Abel Ecology

Document No: 1472-LET-145

Response to exhibition feedback

Figure 1. Extract of Figure 12 from SEPP59 Stage 3

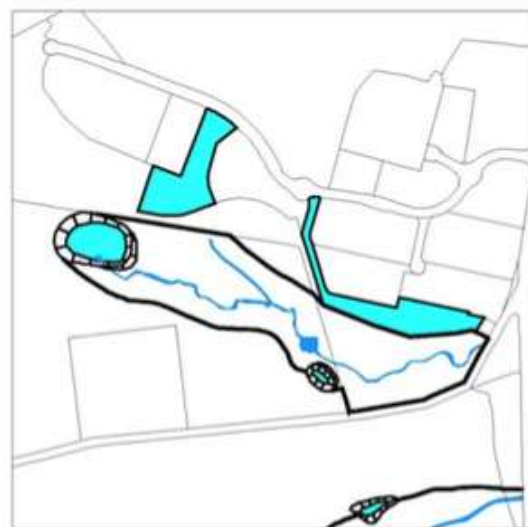
"The Director General's Requirements issued for SSD-6236 require an assessment of the development against State Environmental Planning Policy (Western Sydney Employment Area) 2009. Clause 19 (2) of this SEPP states "in determining a development application that relates to any land to which an existing precinct plan applies, the consent authority is to take the existing precinct plan into consideration". Clause 19(3)(b) of the SEPP lists the Eastern Creek Precinct Plan (stage 3) as an existing precinct plan.

SEPP 59 – Eastern Creek Precinct Plan (Stage 3) includes the following controls 5.6.1 (e), 8.3.5 (b), 8.4.3 (d) which relate to the riparian corridor along Ropes Creek Tributary:

It is assumed the riparian corridor is defined as the polygon displayed in Figure 12 (see below) and Figure 17 page 8-8 of SEPP59 (dated 14 December 2005). No buildings or laydown pad is proposed within this riparian corridor. Parts of the batters for Laydown Area No.5 and parts of the basin edge for the bio-retention basin overlap the riparian corridor. Figure 12 indicates basin edges are acceptable along riparian corridor boundaries

It is noted part of the batter for Laydown Pad No.5 overlaps the eastern portion of the riparian corridor boundary. It is a variation to the control (page 11-17 SEPP 59 –Eastern Creek Precinct Plan (Stage 3) Dated: 14 December 2005), which states:

Figure 7. Close up of vegetation adjacent to Ropes Creek Tributary and adjoining areas.

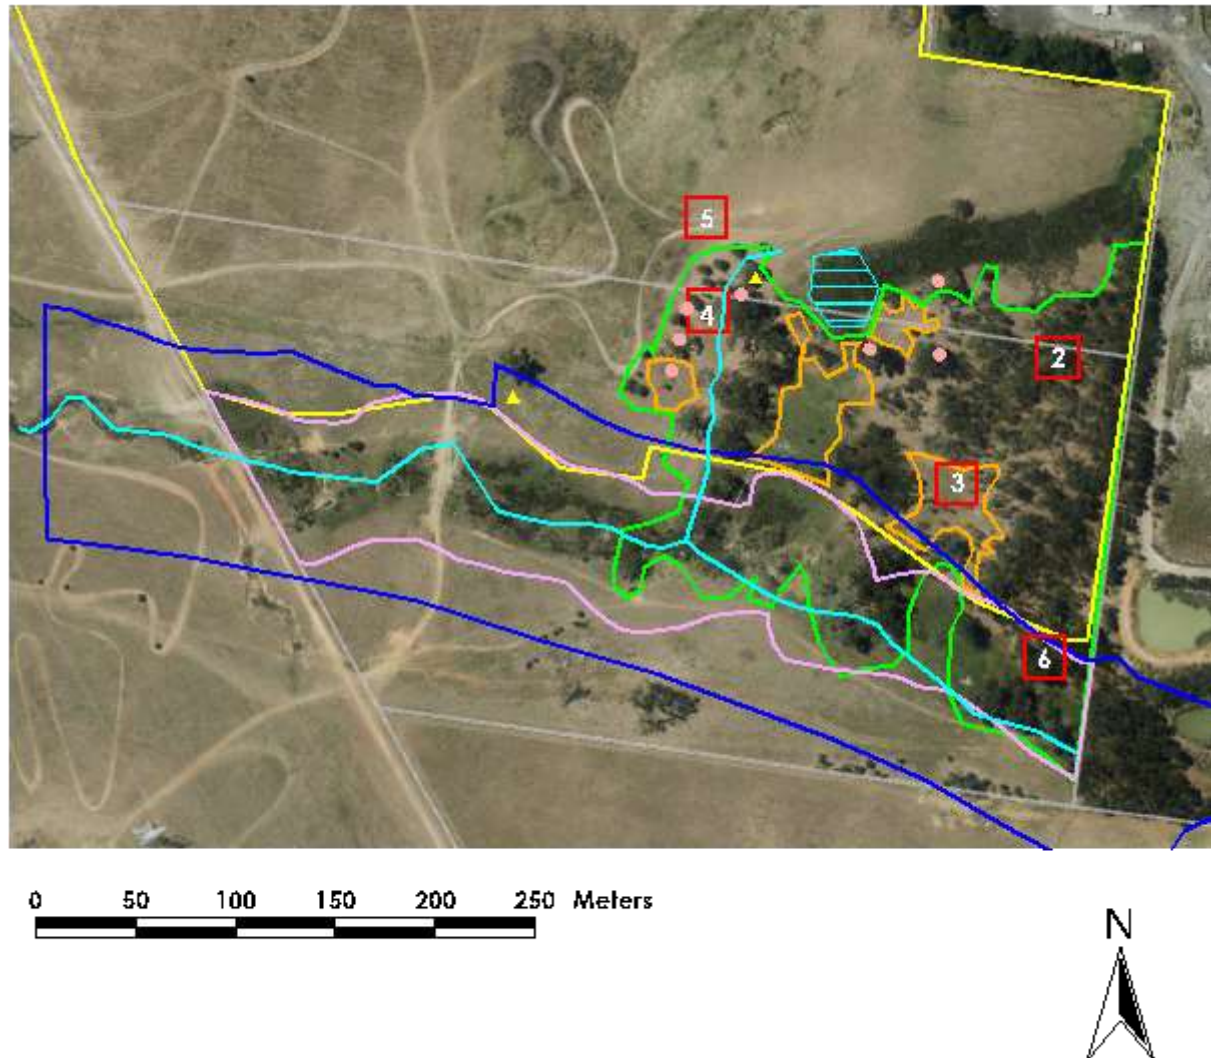
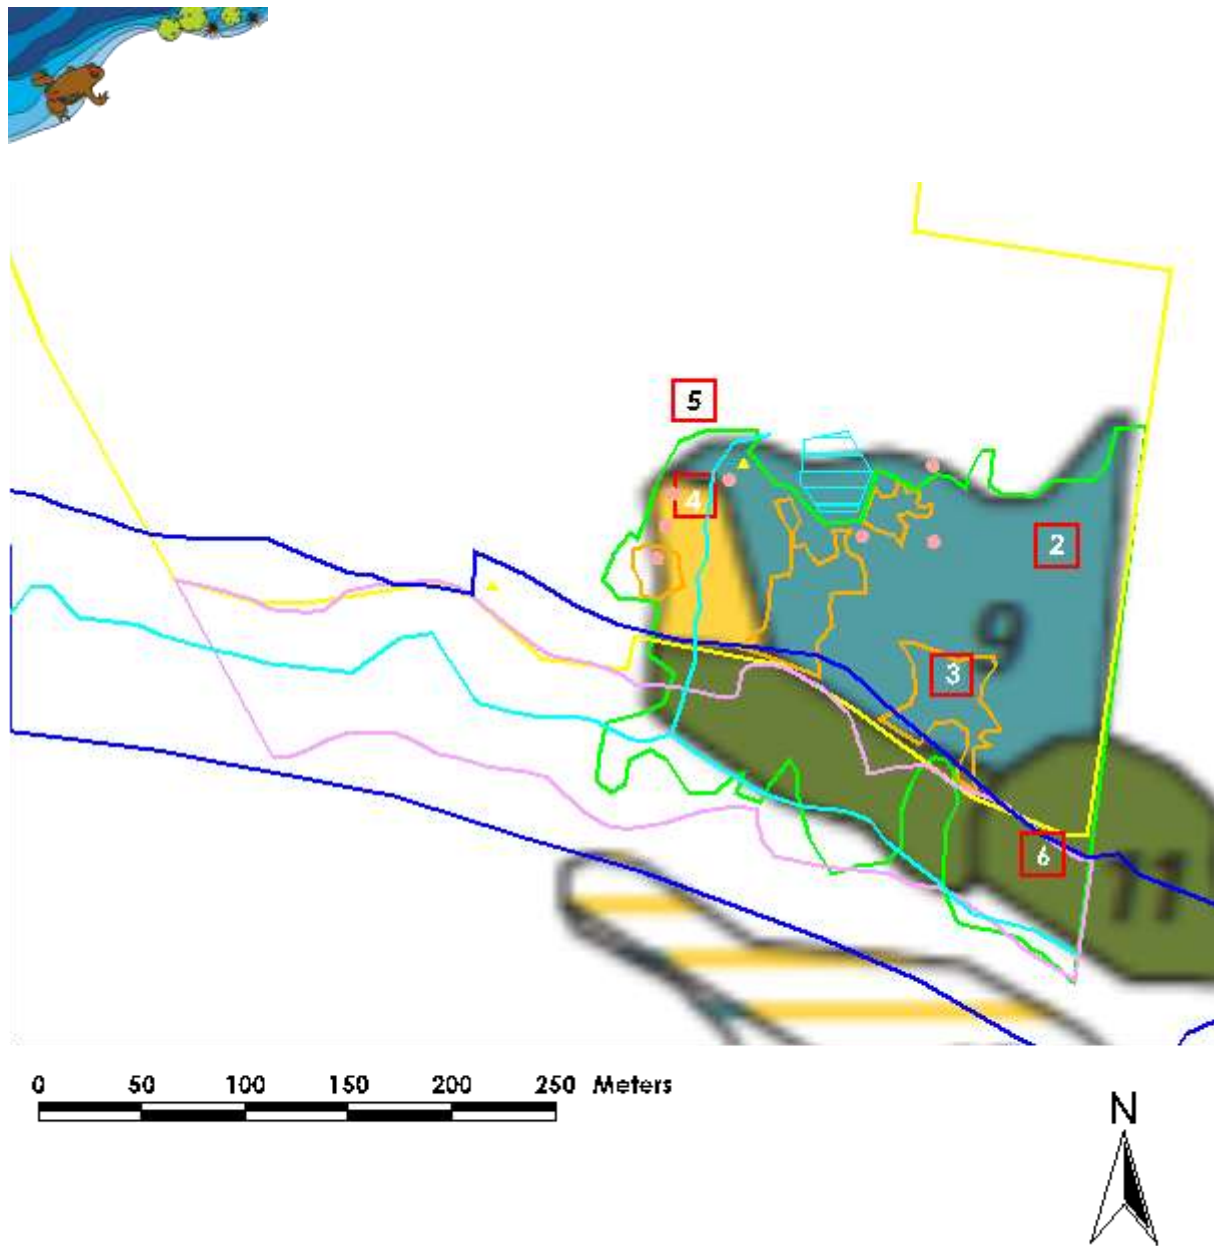
"OEH's previous comments also raised the issue that the report should include data from the quadrats. It is noted that the quadrat data has now been provided and figures in the FFAR display the location of the quadrats, however the quadrats should be numbered in these figures so that the data can be related back to its location."

The figures displaying the locations of the quadrats have been amended and are attached to this document as an amendment (Attachment A).
